STAFF REPORT
COMMUNITY DEVELOPMENT DEPARTMENT

SUBJECT: FP-2025-0004
Addison Circle Subdivision – FP

LOCATION: 4535 N. Black Cat Rd. in the NE 1/4 of
Section 33, T.4N., R.1W. (Parcel
#S0433110460)

I. PROJECT DESCRIPTION

B. Final Plat (date: 3/21/2025)

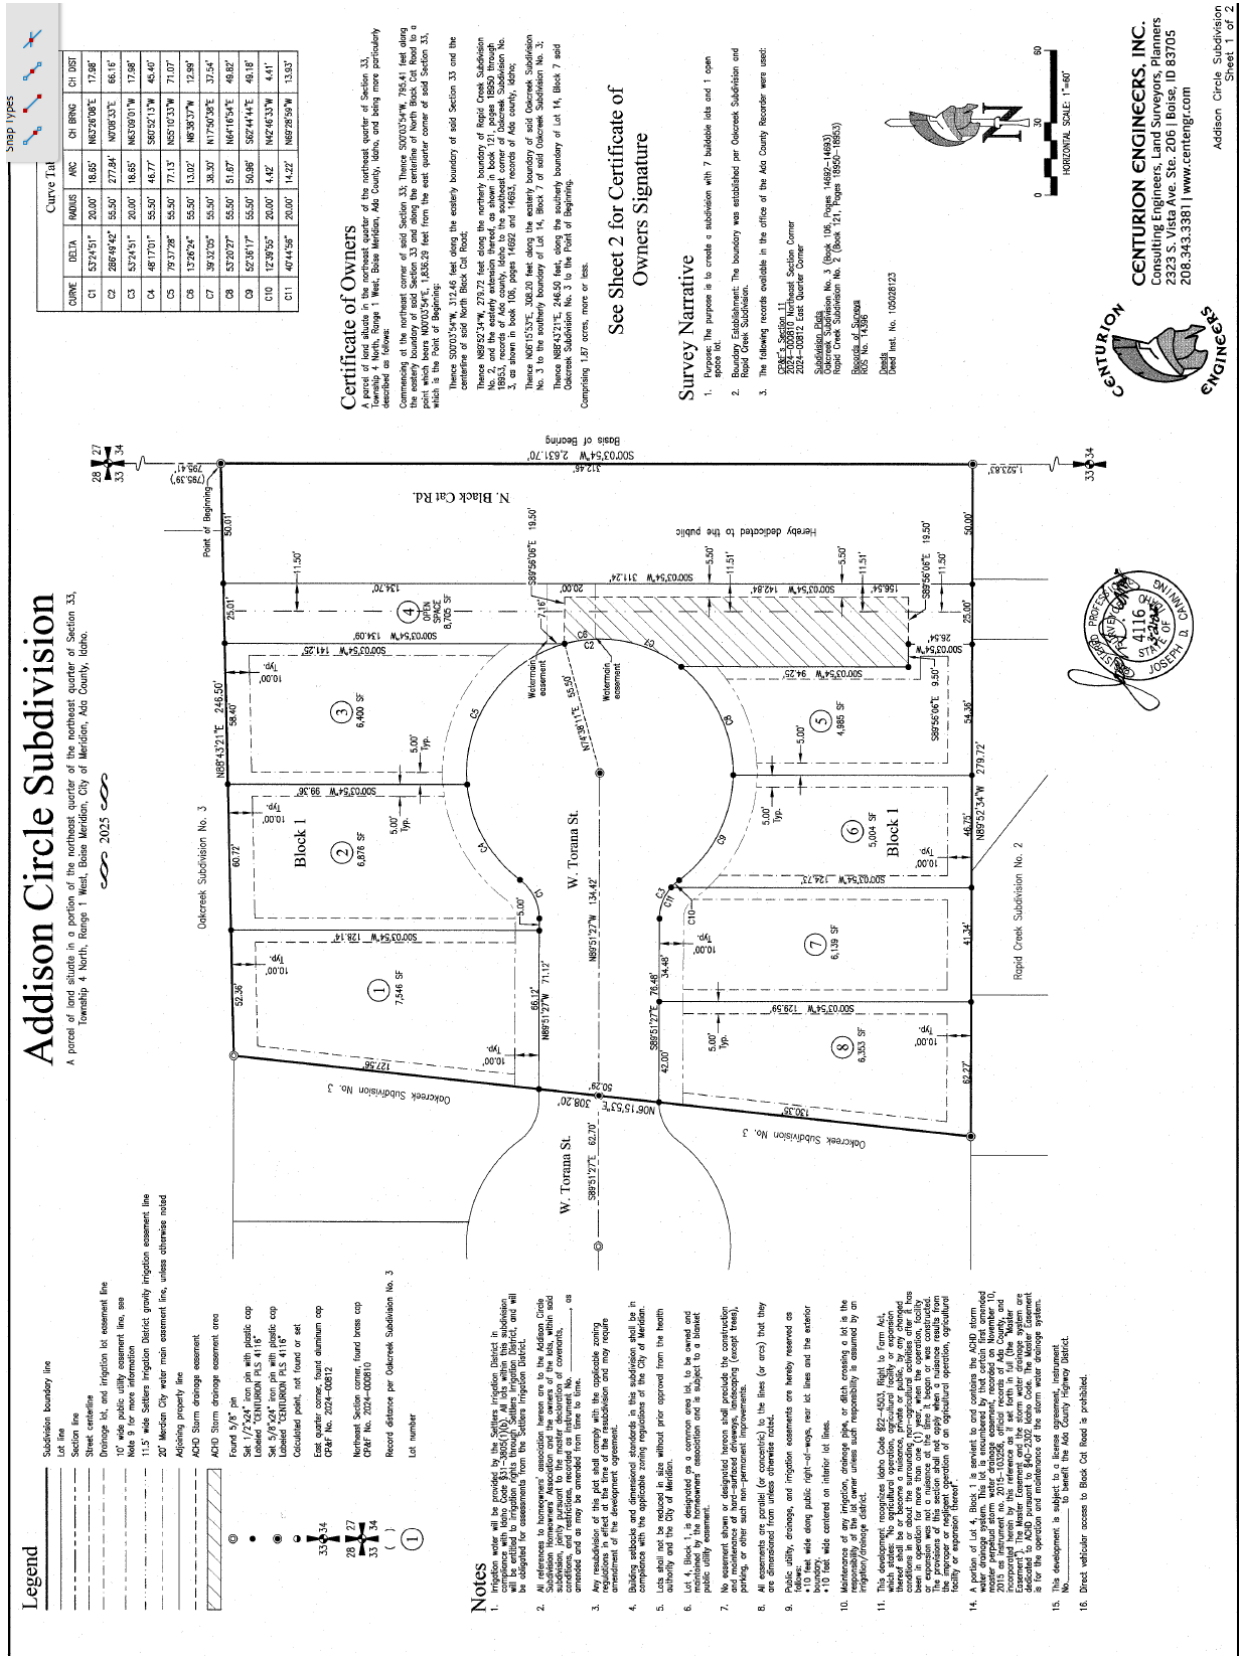
- a. Note #2: Include the recorded instrument number of the CC&R's.
 - b. Note #15: Include the recorded instrument number of the ACHD license agreement.

- c. Correct the horizontal scale – it should be 1"=30', instead of 1"=60'.

The revised plat shall be submitted with the application for final plat signature.
